BID ADDENDUM NO. 1

PROJECT NAME: KING STREET ELEMENTARY SCHOOL
BOILER REPLACEMENT
SED #: 66-19-04-03-0-007-015

DATE: February 16, 2023

DRAWING KSES H301 – KING ST ES DETAILS AND SCHEDULES

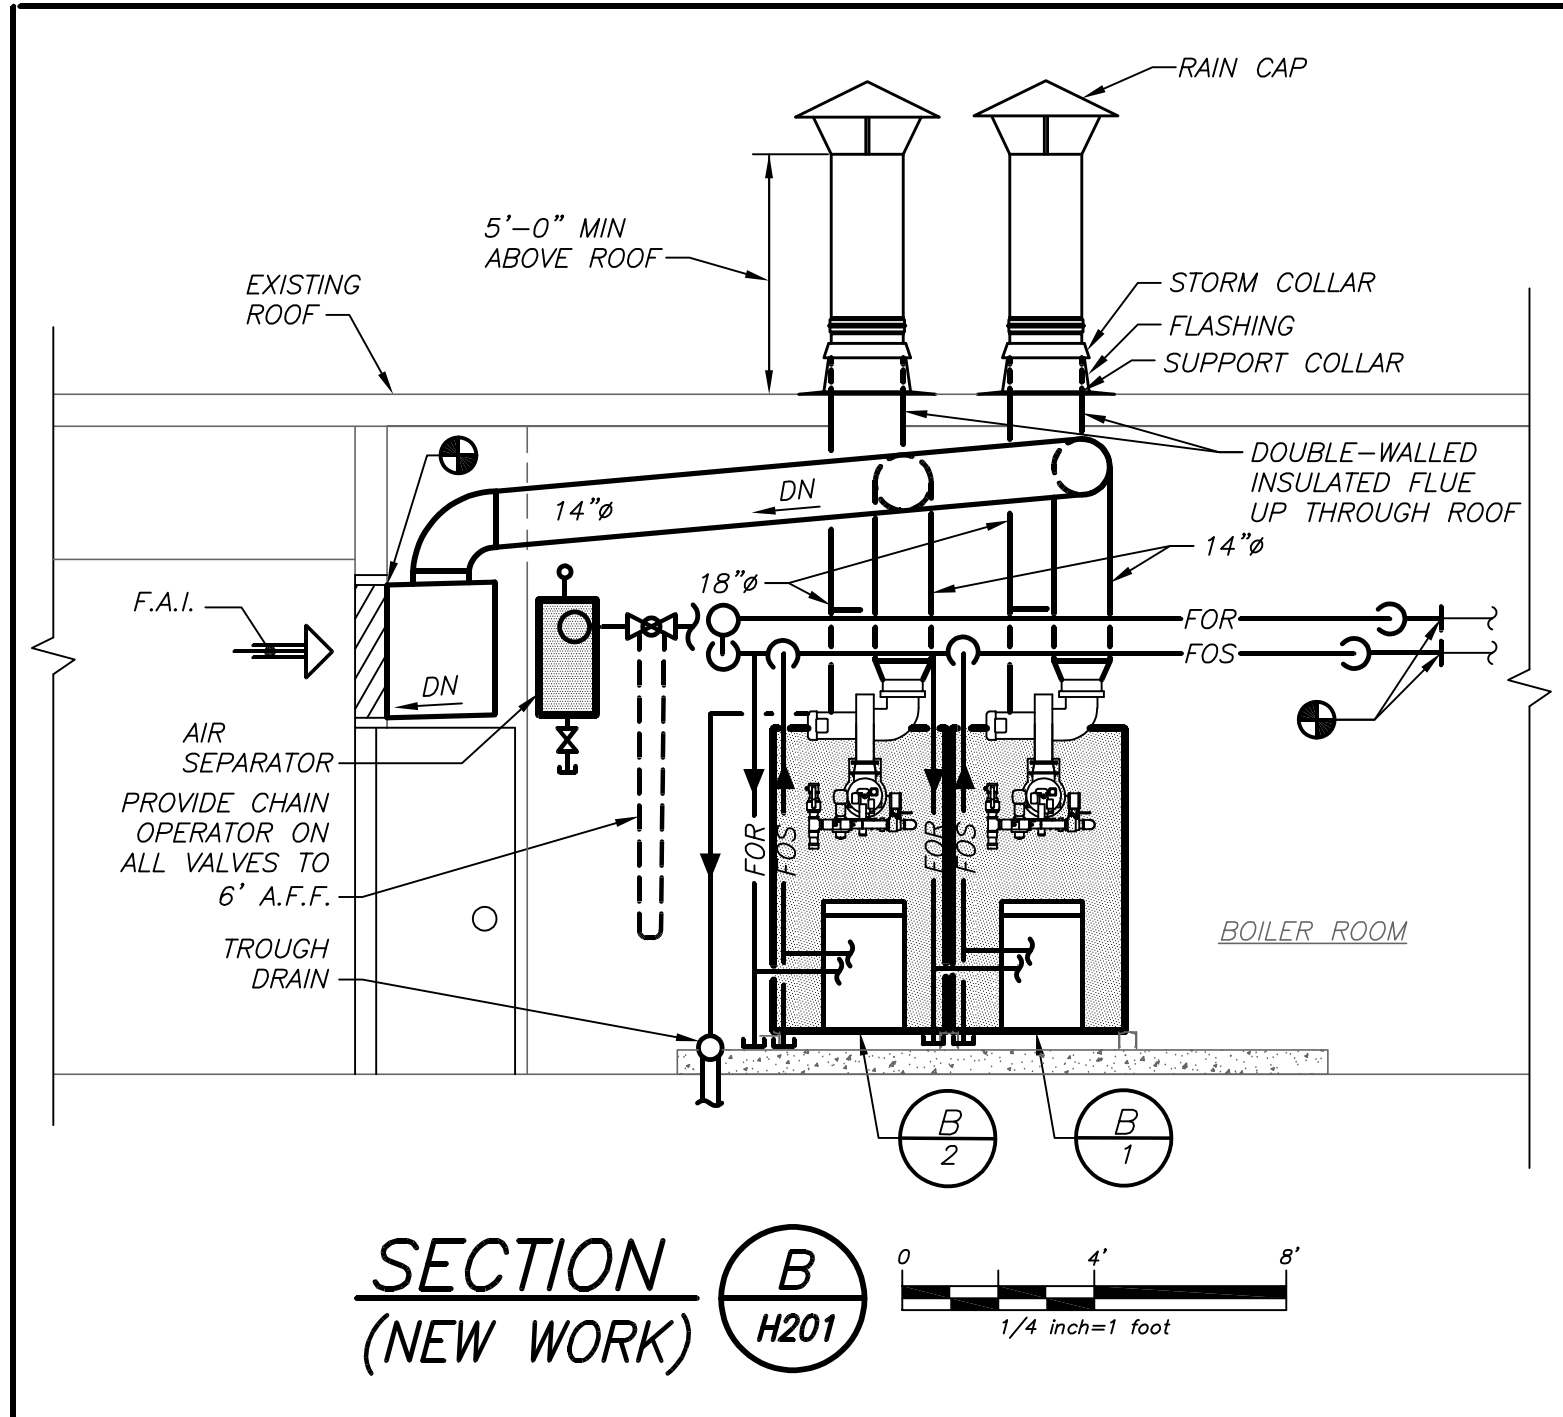
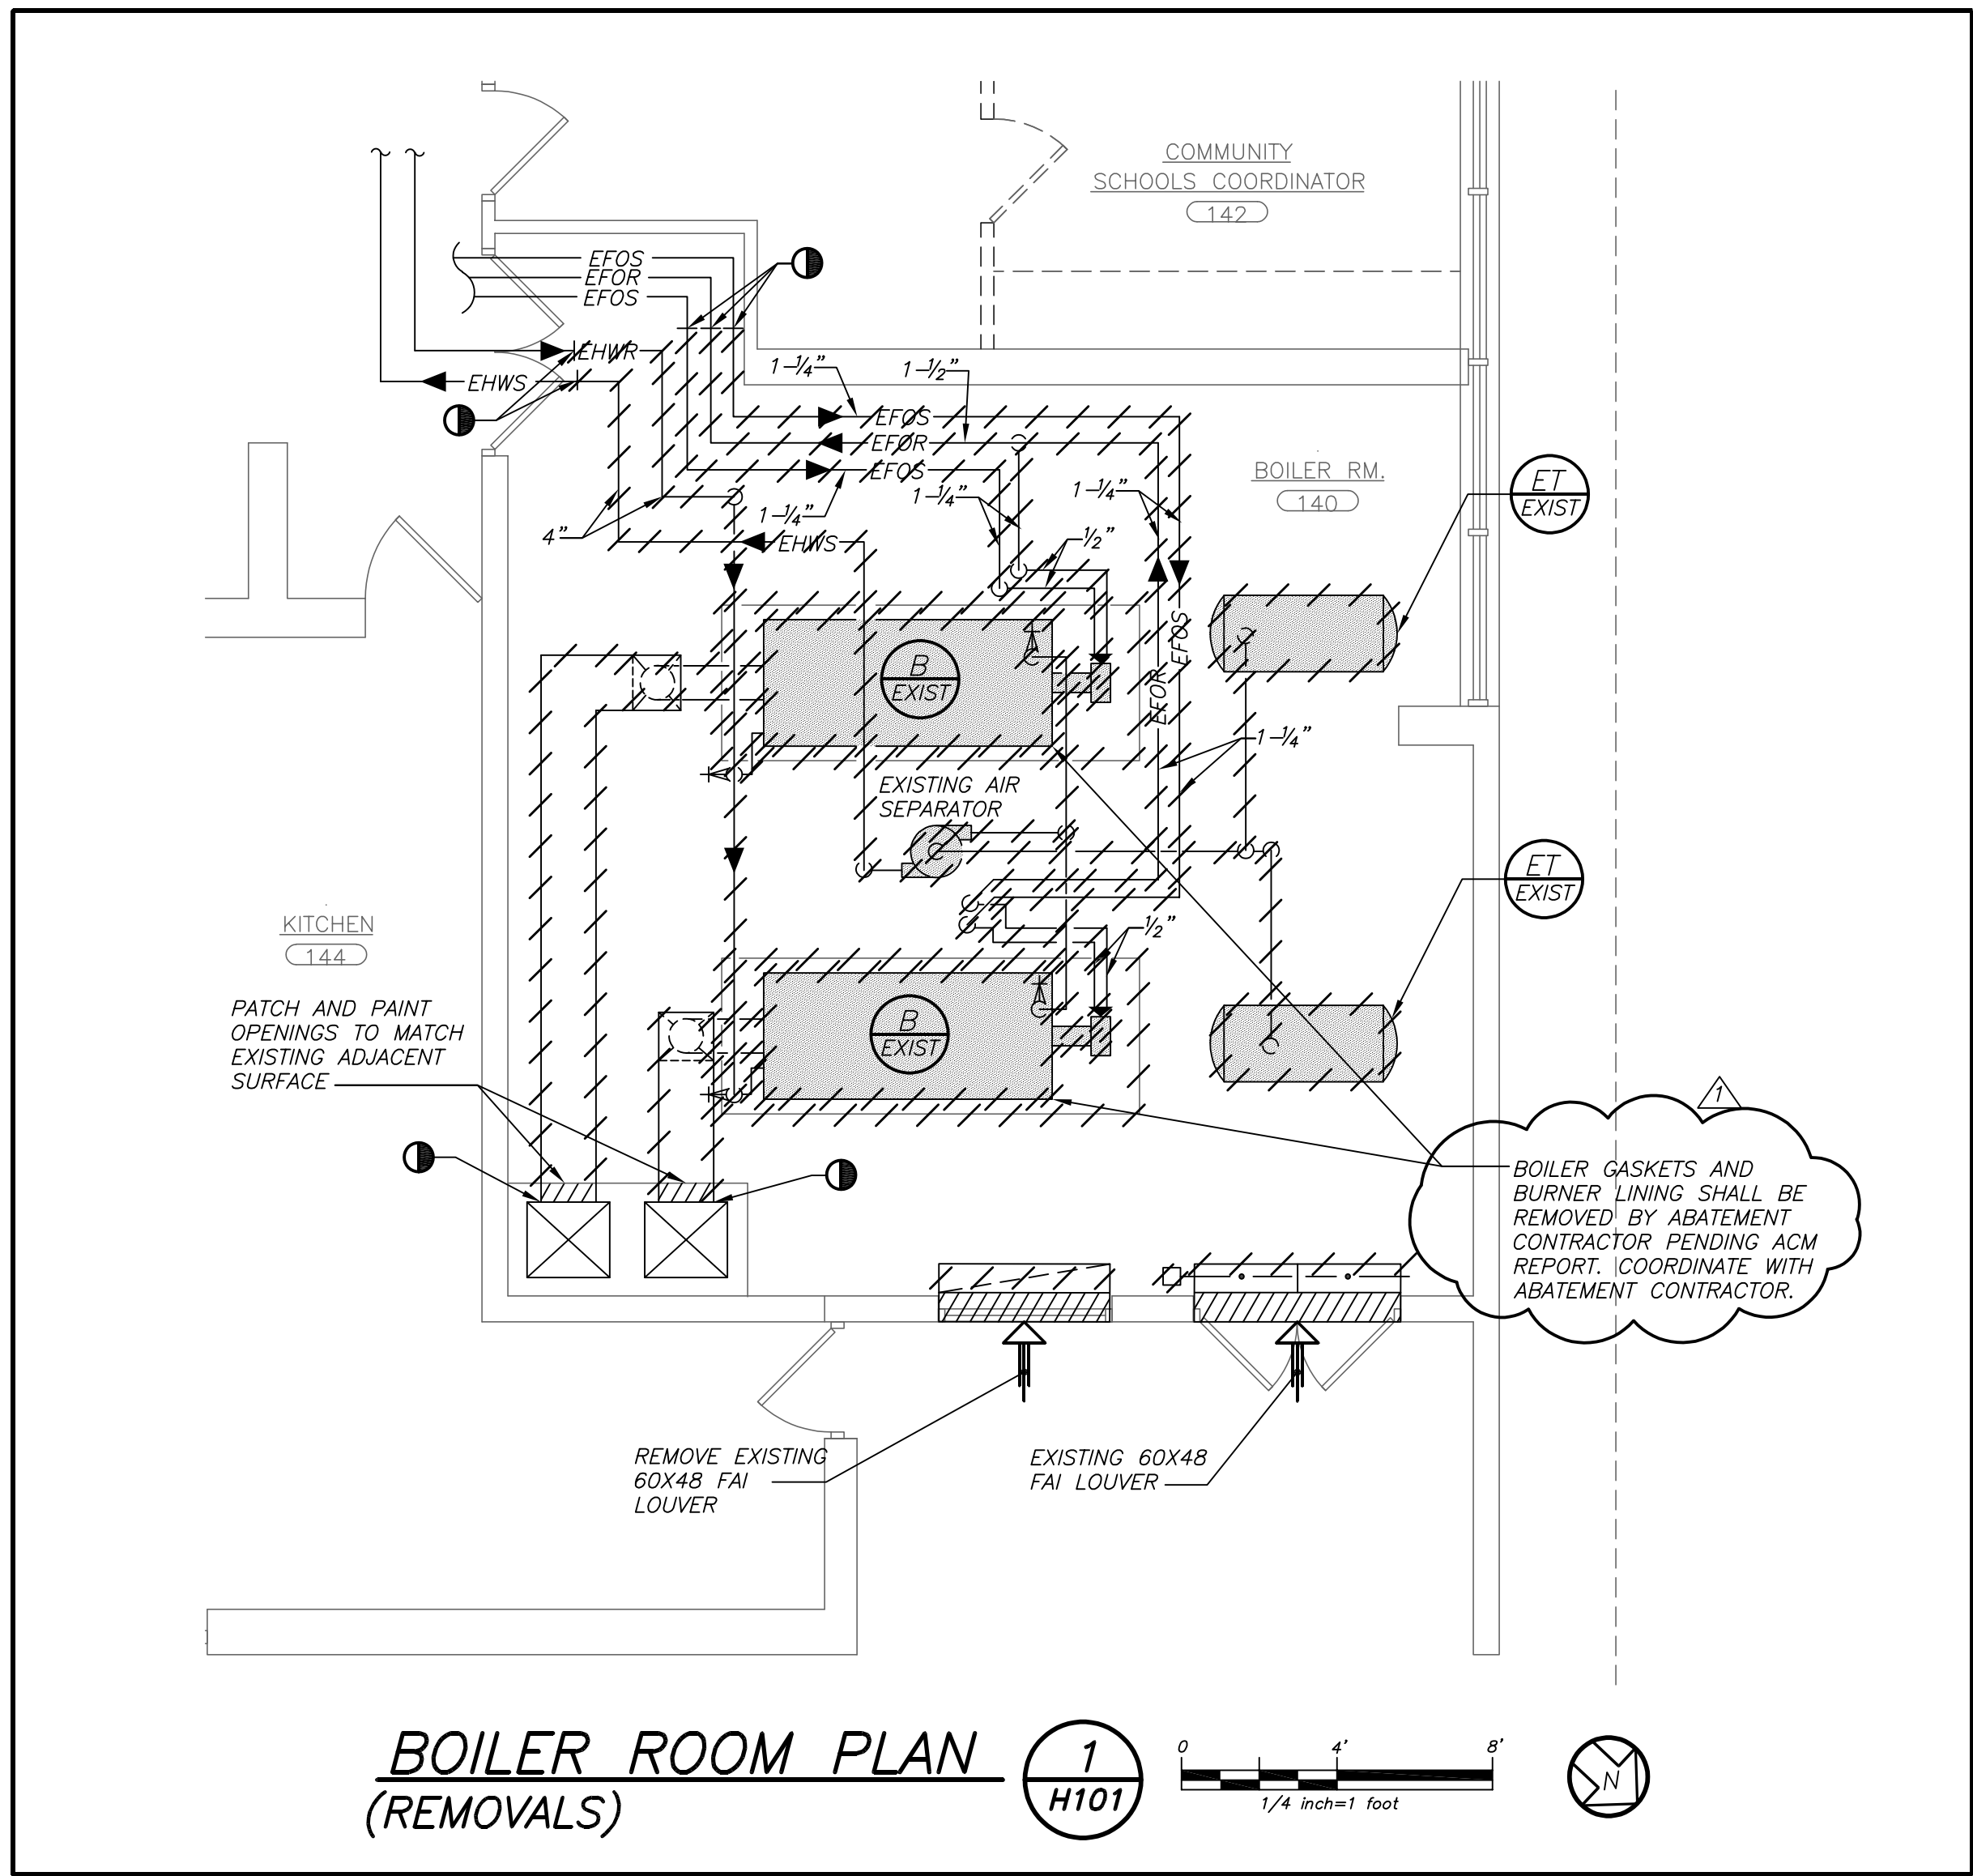
- 1. 1/H201 – BOILER ROOM PLAN (REMOVALS)
 - a. Include note “Boiler gaskets and burner lining shall be removed by abatement contractor pending ACM report.
Coordinate with abatement contractor”. See attached drawing.
- 2. 2/H201 – FAN ROOM PLAN (NEW WORK)
 - a. Modify note for Alternate MC-1 to include chemical feeder. See attached drawing.
- 3. 3/H201 – BOILER ROOM PLAN (NEW WORK)
 - a. Include note “Replace all vibration isolators on piping”. See attached drawing.
- 4. 4/H201 – PUMP STATION PIPING SCHEMATIC (ALTERNATE)
 - a. Replace tags HWP-1 and HWP-2 with HWP-3 and HWP-4. See attached drawing.
